## ADDENDUM #1

Reference: Fire Alarm System Upgrade – Cedar City Firth District Court  
Administrative Office of the Courts  
DFCM Project No. 06109150

**Subject:** Revisions to Fire Protection Drawings for Addendum 1

DETAILS  
FA-2

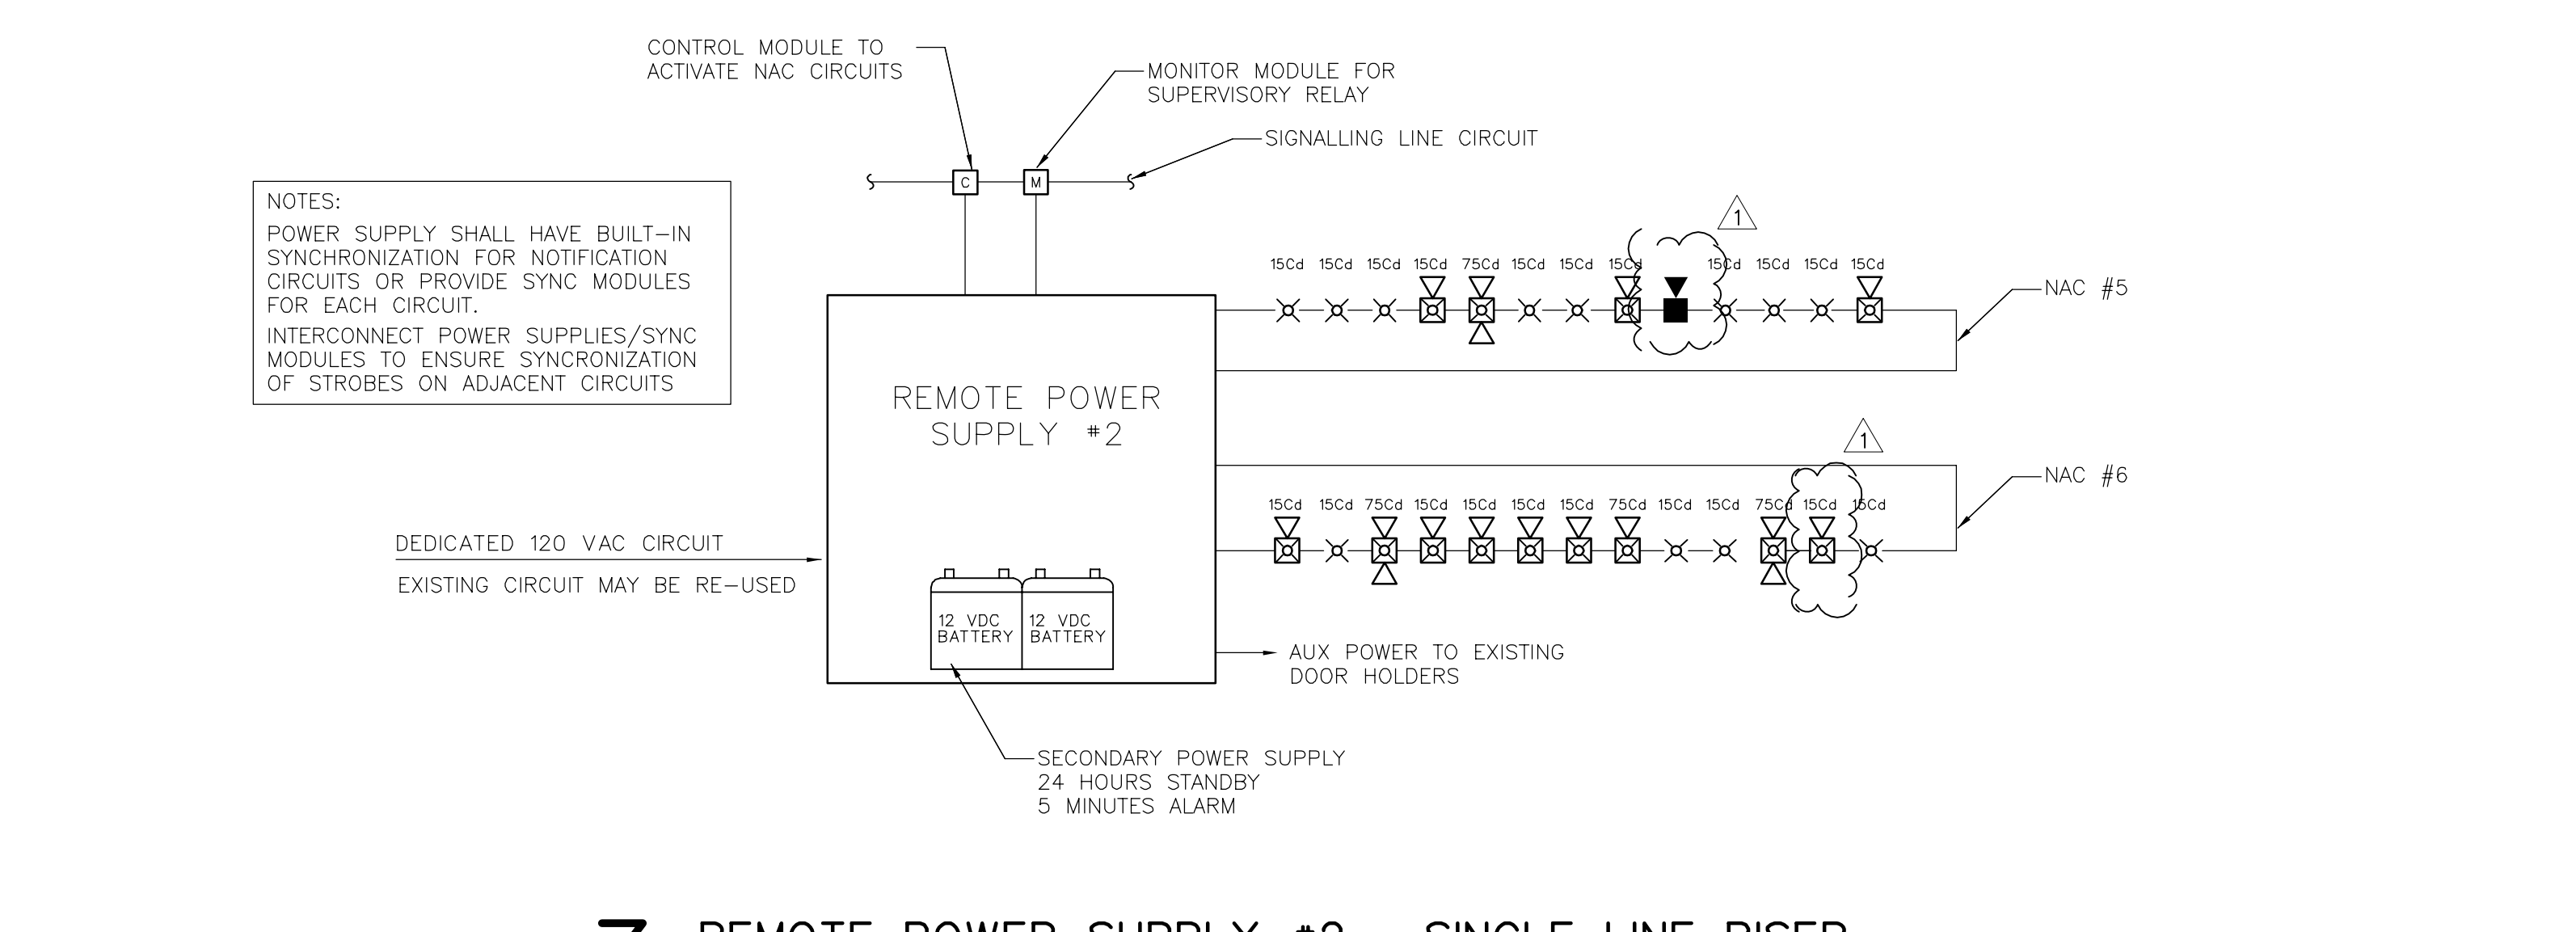
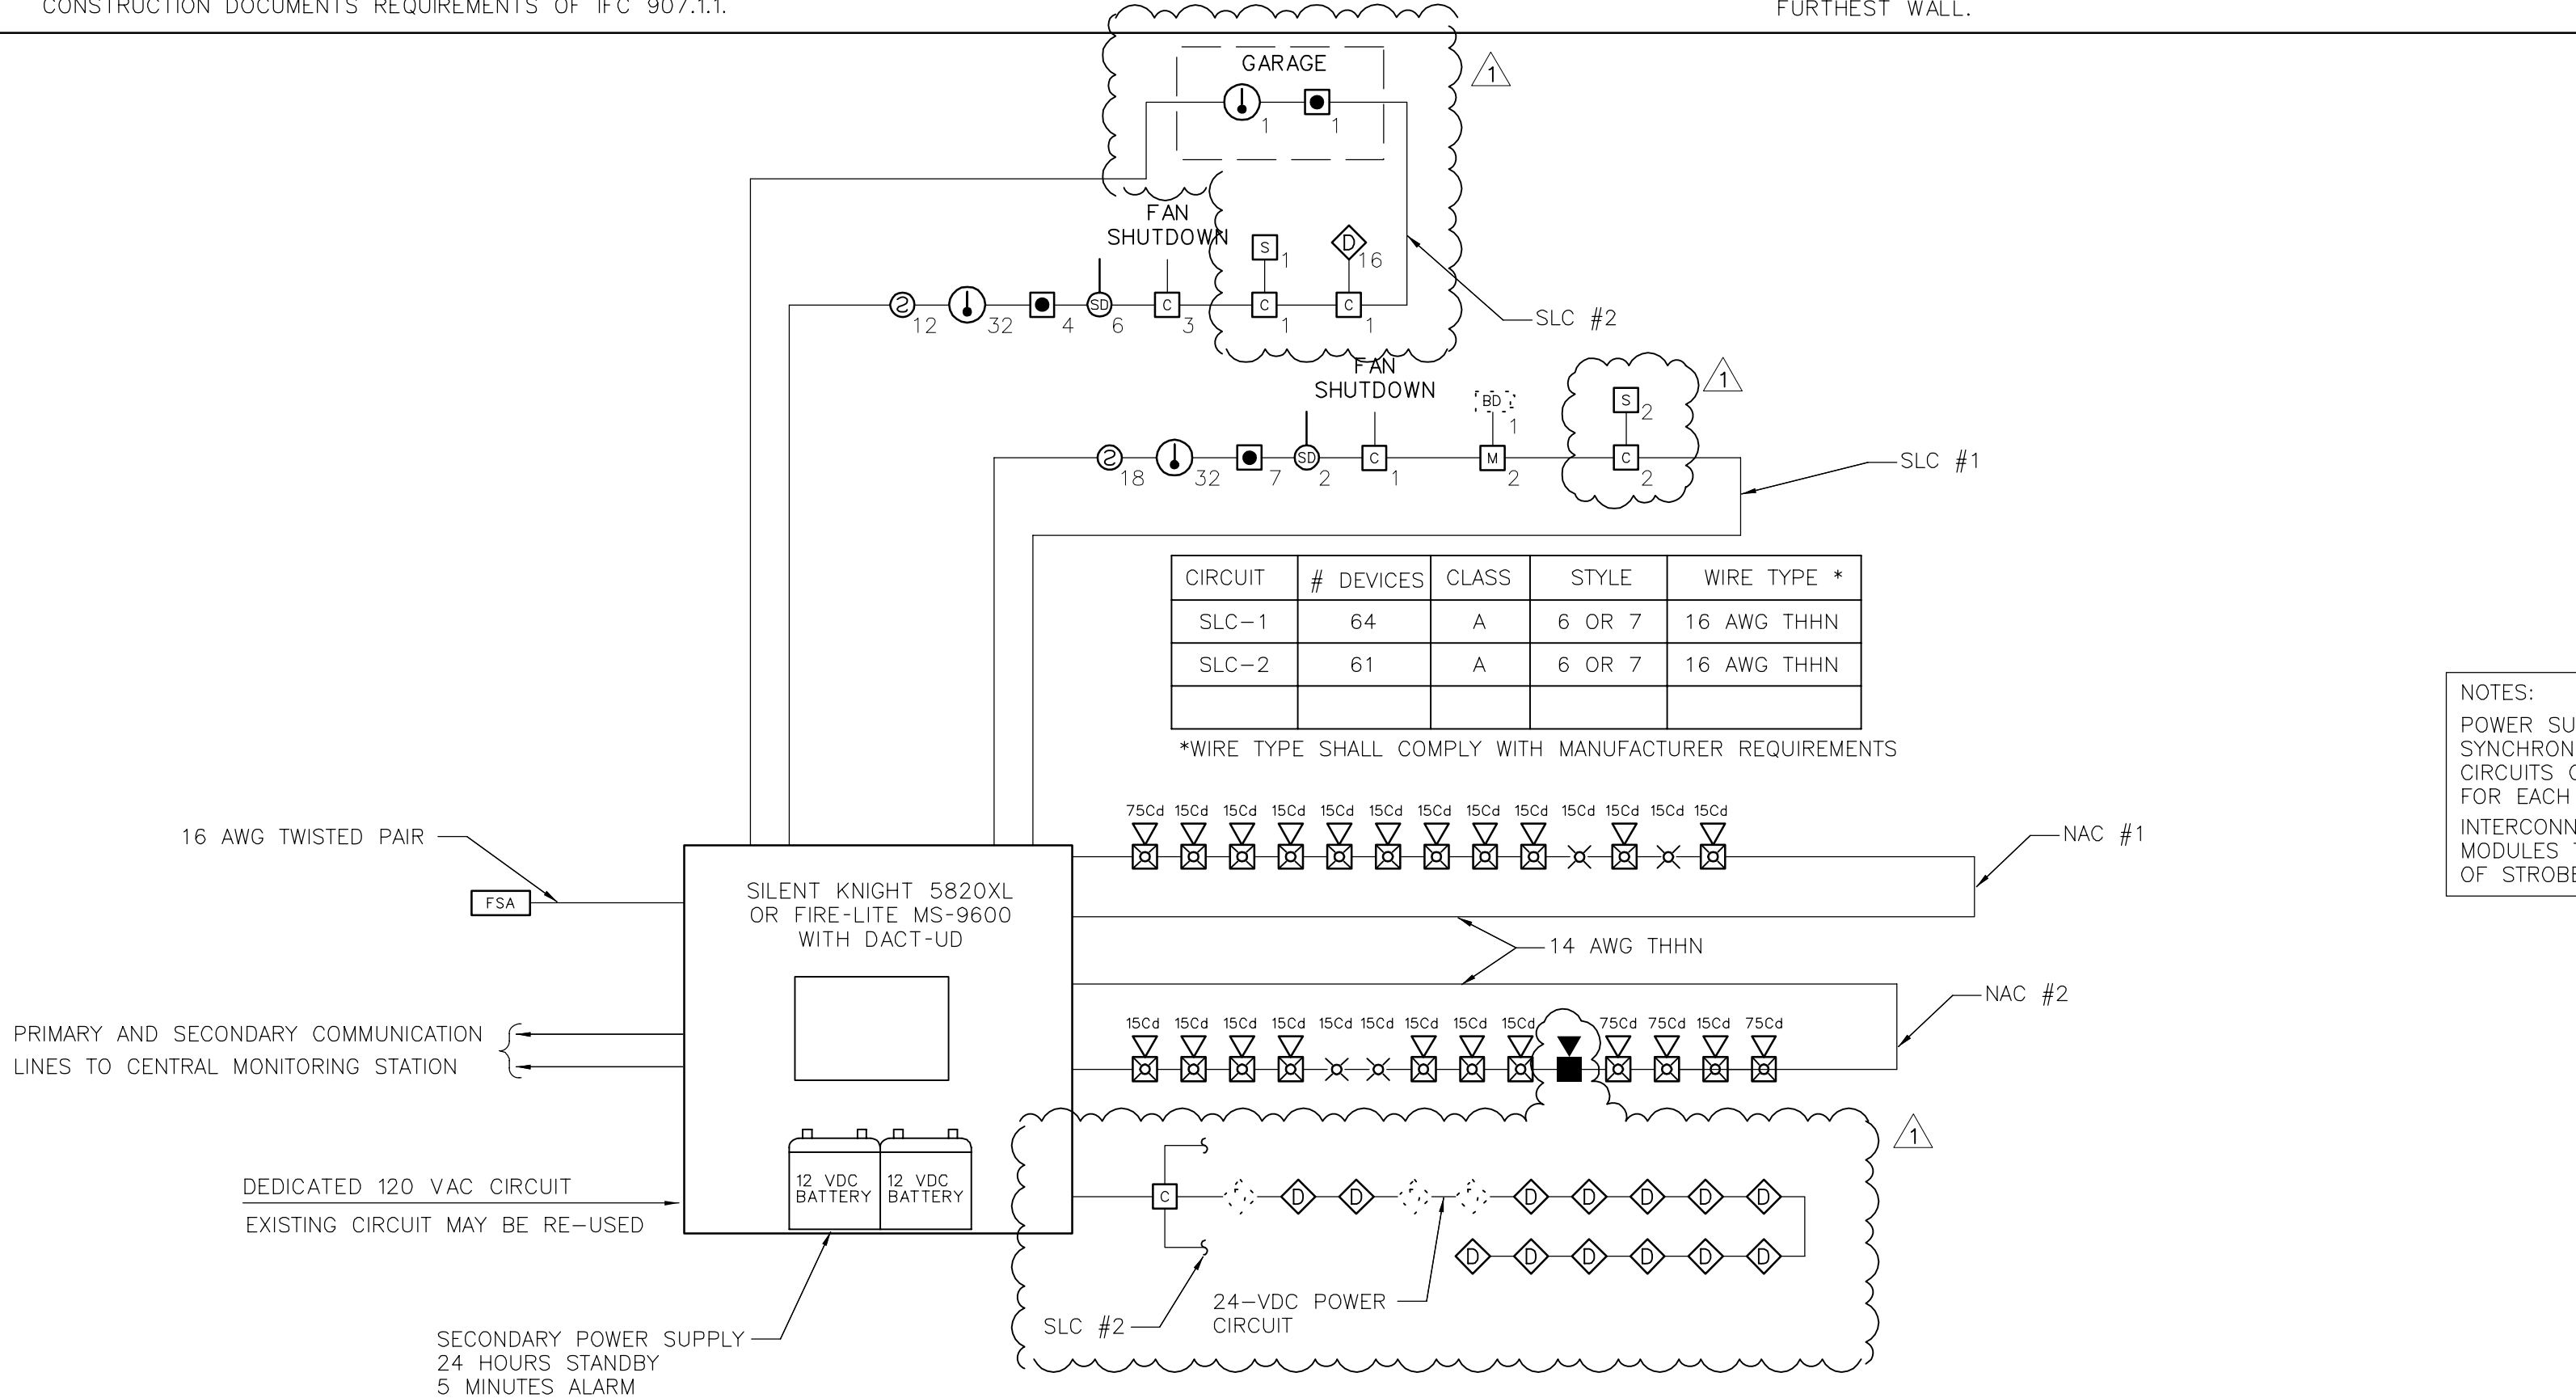
**Sheet FA-2:**

9. Updated notification circuit detail per addition of 3 exterior horns and 1 horn strobe in garage.
10. Added one pull station and one heat detector to SLC-2 for garage on FACP riser detail.
11. Removed control modules for secure door release from SLC circuits on FACP riser detail.
12. Added control modules on FACP riser detail for door strike release at delayed egress doors.
13. Updated quantity of devices reported for each SLC.
14. Edited sequence of operation to indicate that duct smoke detectors shall be programmed to provide a supervisory signal.
